**CITY OF VAUGHAN
COMMITTEE OF THE WHOLE
ADDENDUM AGENDA**

Tuesday, March 5, 2019

**TITLE: OFFICIAL PLAN AMENDMENT FILE OP.18.016
ZONING BY-LAW AMENDMENT FILE Z.18.028
YONGE & STEELES DEVELOPMENTS INC. C/O
THE GUPTA GROUP
VICINITY OF YONGE STREET AND STEELES AVENUE WEST**

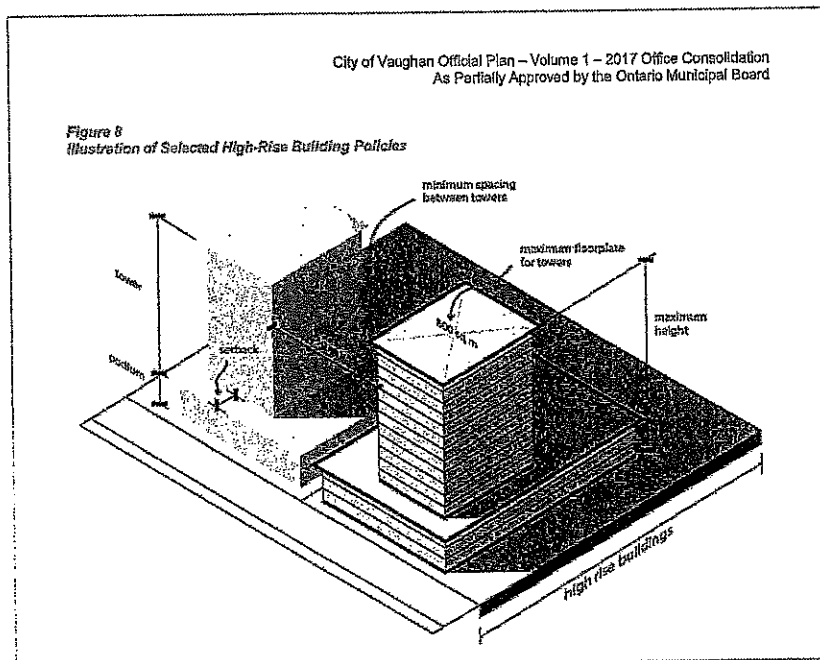
Tower 2 and Tower 3 look to be closer together than the minimum 30m. allowed by Vaughan.

Attachment 3: Site Plan

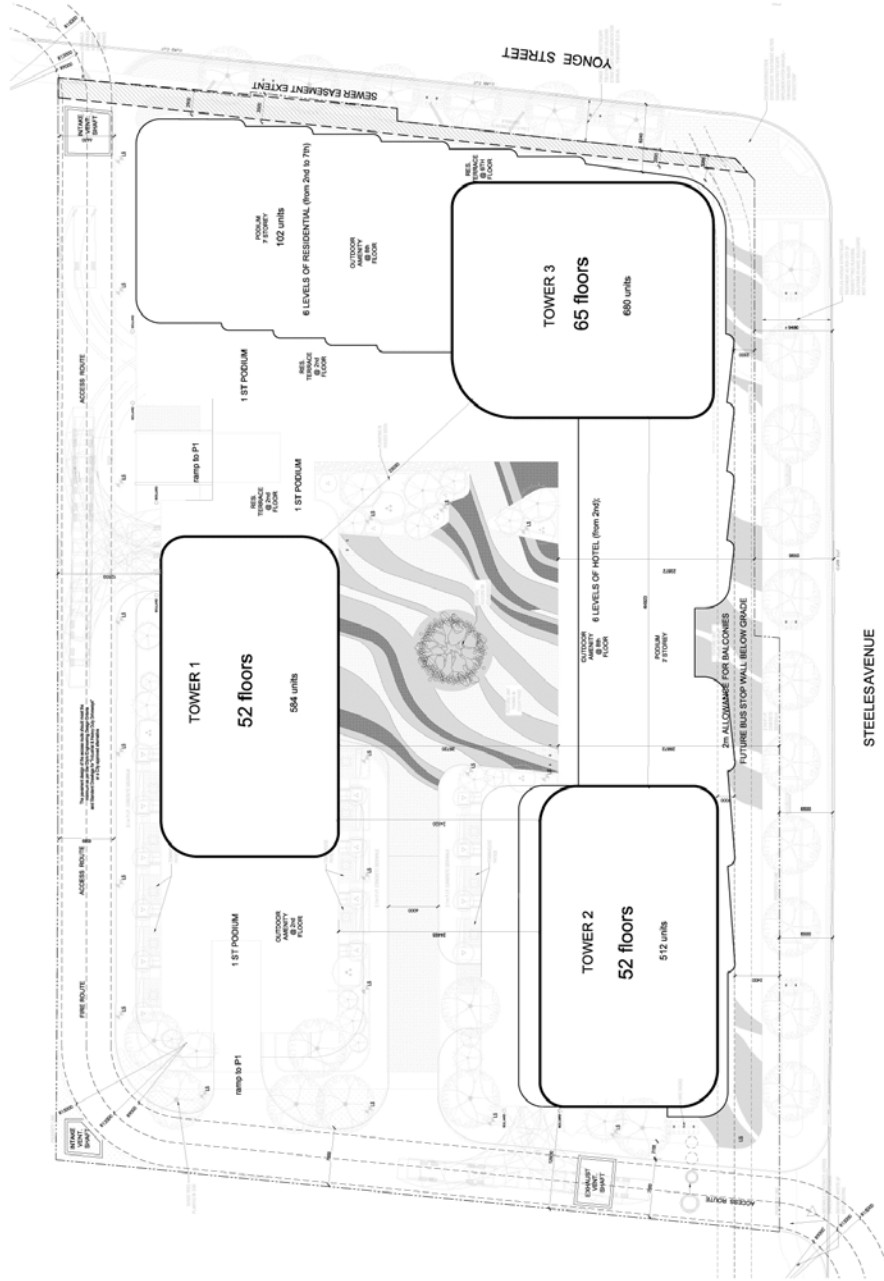
- The subway access shown on the ground floor plan does not align with anything on any below grade drawing. Please have the applicant clarify how the building would connect to the future subway station.

Figure 1: Appendix C (south) – Existing Property Parcels, Proposed Local Streets, Parks & Publicly Accessible Open Space, YSCSP

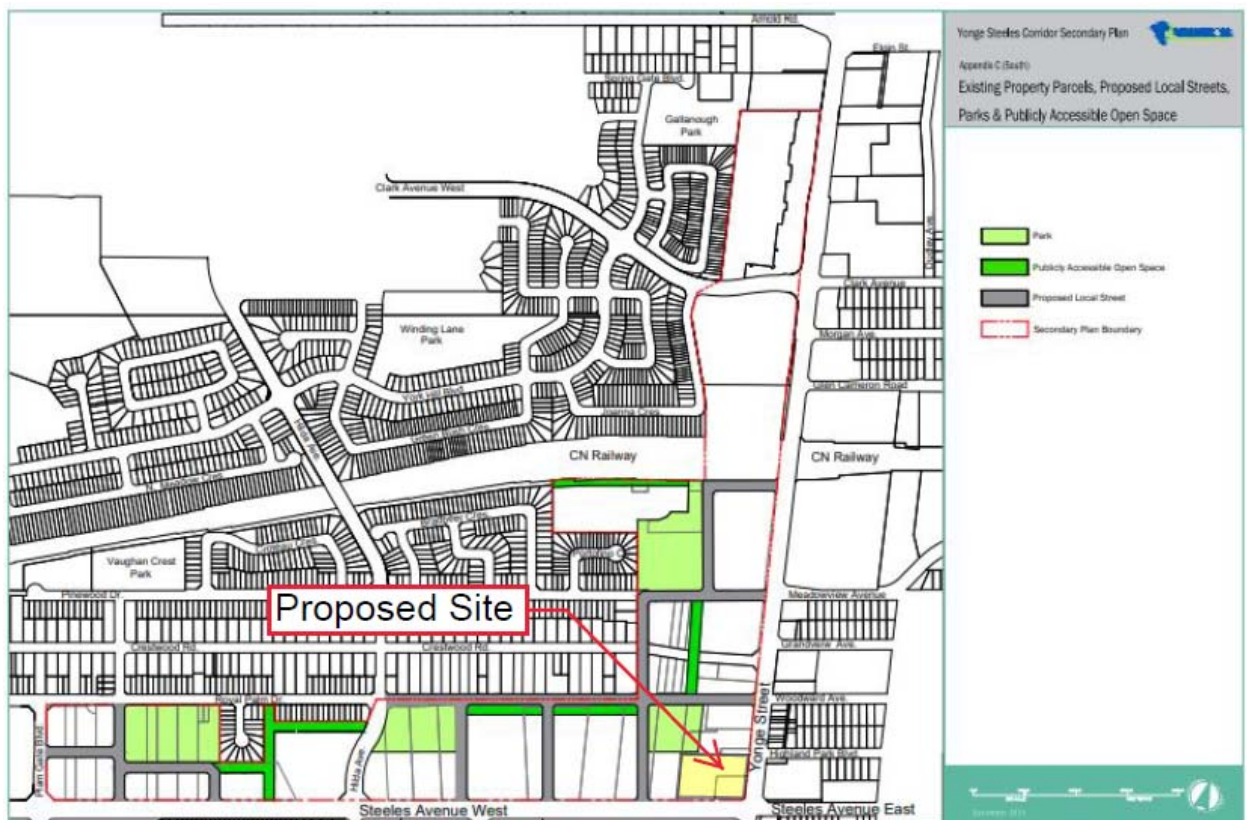
6. A Quadrant Level Study should be conducted, in coordination with adjacent landowners, to provide mutual services, infrastructure and benefits to all properties in the northwest quadrant of Yonge and Steeles intersection. See *Schedule 5 (south) – Proposed Local Streets*, YSCSP or see *Appendix C (south) – Existing Property Parcels, Proposed Local Streets, Parks & Publicly Accessible Open Space*, YSCSP.

The Quadrant Study can evaluate, amongst other needs, a connected, coordinated, porous laneway network providing better interconnectivity within the quadrant and better
